Work Order ID 113624

Item Name: Deflector

APICAL INDUSTRIES, INC.	ENGINEERING CHANGE NOTICE NO. 03694				SHEET 1 OF 1	
	DWG NO. 646.2900	REV: N/C	PREPARED BY B. PETERS	DATE: 11/14/12	EFFECT ON DWG <input type="checkbox"/> INC. <input checked="" type="checkbox"/> UNINC.	
	DWG TITLE: DEFLECTOR					
	APPROVED BY: ENGR <i>JKL</i>	MFG <i>Don Baker</i>	QC <i>[Signature]</i>	EFF: NEXT ORDER		
TRANSACTION CODES (TC) A-ADD C-CREATE R-REVISE D-DELETE	REASON: ADDED ALTERNATE MATERIAL.				ECR: D-12-002

ENGINEERING CHANGE NOTICE I				03207		SHEET 1 OF 1	
DWG NO. 646.2900		REV: N/C		PREPARED BY PB	DATE: 08/29/11		EFFECT ON DWG <input type="checkbox"/> INC. <input checked="" type="checkbox"/> UNINC.
DWG TITLE: DEFLECTOR							
APPROVED BY:	ENGR <i>[Signature]</i>	MFG <i>[Signature]</i>	QC <i>[Signature]</i>	EFF: CURRENT ORDER			
TRANSACTION CODES (TC): A-ADD C-CREATE R-REVISE D-DELETE		REASON: ADDED ALTERNATE BASE MATERIAL

646.2910

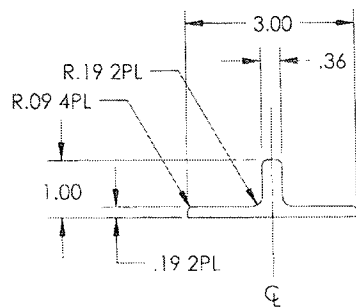
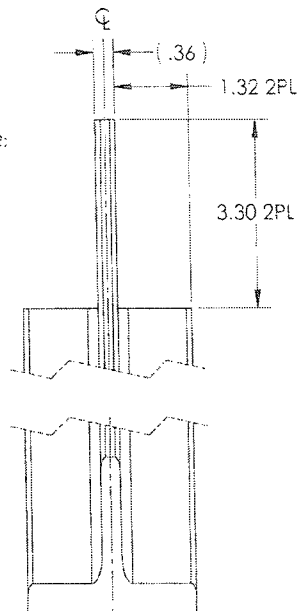
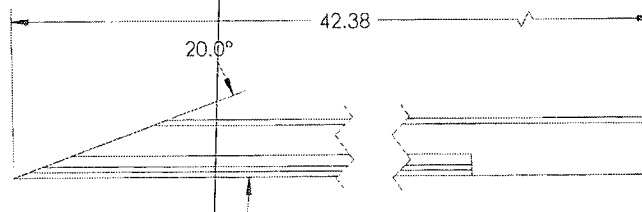
△ PRIMARY MATERIAL: 7075-T6 ALUMINUM PER AMS-QQ-A-225/9.
ALTERNATE MATERIAL: 7075-T6511 ALUMINUM PER AMS-QQ-A-200/11.

SHEET 1, ZONE A2 IS:

SHEET 1, ZONE A2, NOTE 1 IS:

- 1 MATERIAL: 7075-T6 ALUMINUM PER AMS-QQ-A-225/9 OR AMS-QQ-A-250/12
- 2 FINISH: HARD ANODIZE IAW MIL-A-8625 TYPE III CLASS 2,
COLOR BLACK; CARDINAL 4860-50 PRETREATMENT PRIMER;
PRIME IAW MIL-P-23377J TYPE I CLASS N
3. DEBURR AND BREAK ALL SHARP EDGES
4. IDENTIFY IAW MPP-120
